AGENDA
PLANNING AND ZONING COMMISSION MEETING
CITY OF CREVE COEUR, MISSOURI
MONDAY, FEBRUARY 3, 2014
7:00 PM

A. Application 13-047: Conditional Use Permit for an assisted living facility, The Grove in Creve Coeur, located at 450 N. Lindbergh Blvd.

APPLICATION TO PLANNING AND ZONING COMMISSION #13-047 APPROVAL OF A CONDITIONAL USE PERMIT FOR AN ASSISTED LIVING FACILITY AT 450 N. LINDBERGH BLVD

Figure 3: Close-up of Landscape Plan at north east corner of building.

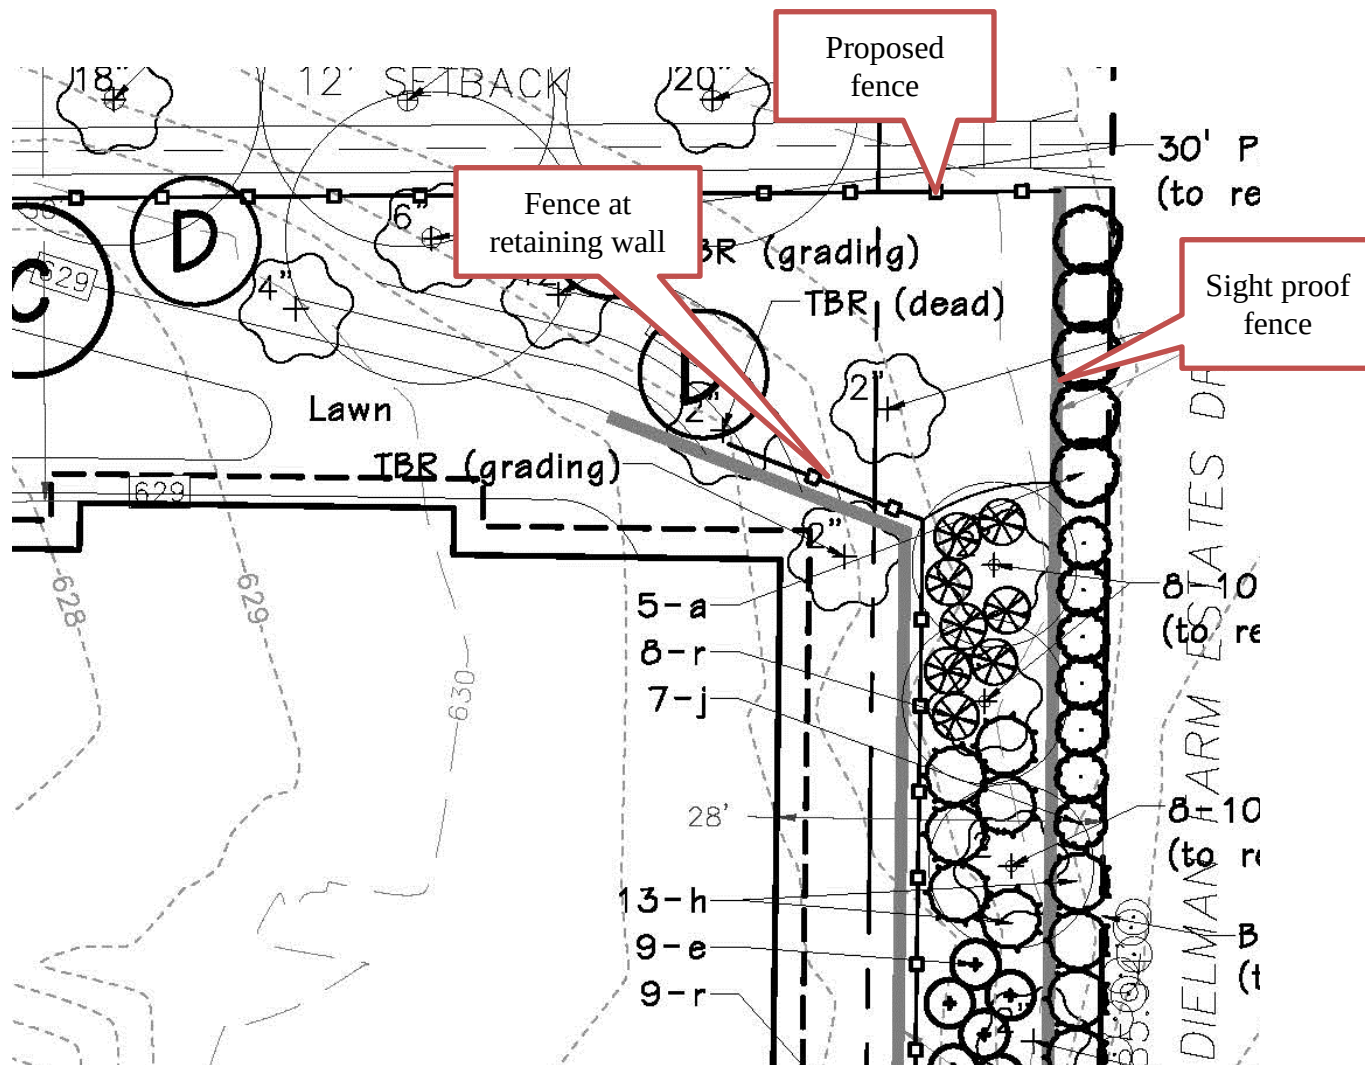
Staff recommends that the placement of the sight-proof fence along the east property line not extend any further north than the building, and the fence along Beaver Drive should be minimized and returned to the building at the earliest possible point. If the Commission wishes to include the fence along Beaver Drive, Staff recommends that a condition of the approval require the fence be a black open-slatted, wrought-iron style fence with additional landscaping to meet with the Comprehensive Plan and prior Commission action. With the enclosing of the property, the internal fencing enclosing the courtyard and on top of the retaining wall seem unnecessary and should be removed.

Figure 5: Close-up of the Landscape Plan

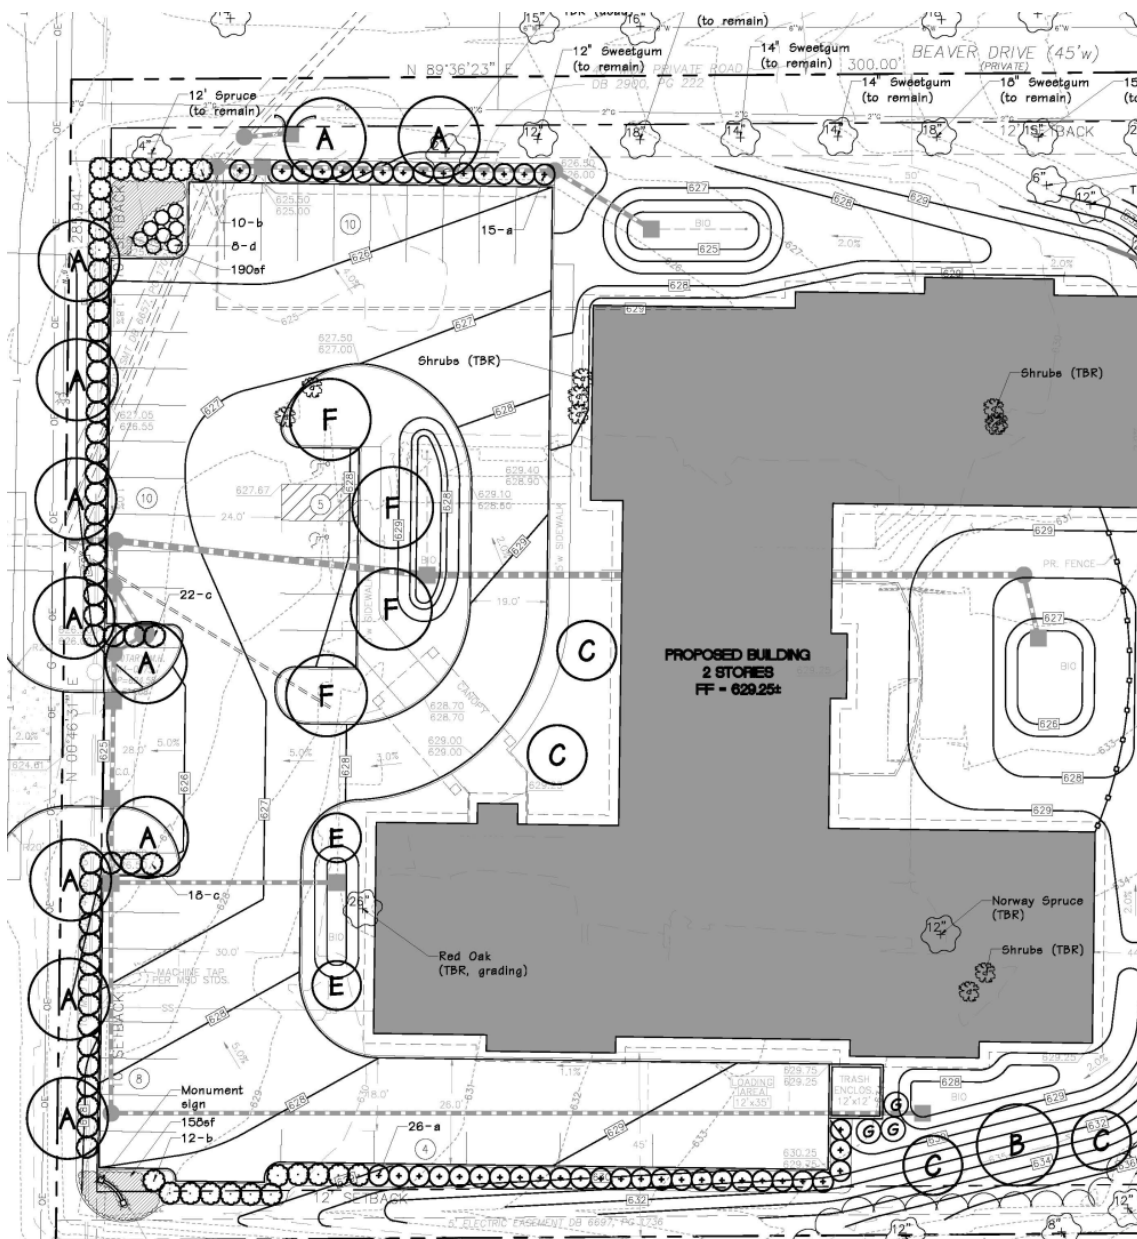
The submitted landscape plan shows that the Applicant will maintain all of the existing live trees along Beaver Drive (one is already dead and will be replaced with two new trees) and along the east property line to provide screening to the adjacent residential structures. Street trees and landscaping are provided throughout the site to provide screening of the parking lot, and along Lindbergh Boulevard that meets with the minimum requirements of the Zoning Ordinance. However, the overall design does not provide much interest and is a very plain design. Further the interior landscaping next to the building and within the islands is lacking in design and is very sparse; as shown on the plan below:

Staff recommends that the Applicant revise the landscape plan to provide additional landscaping that more fully meets with the Design Guidelines, especially in the parking lot and along the north side of the building.
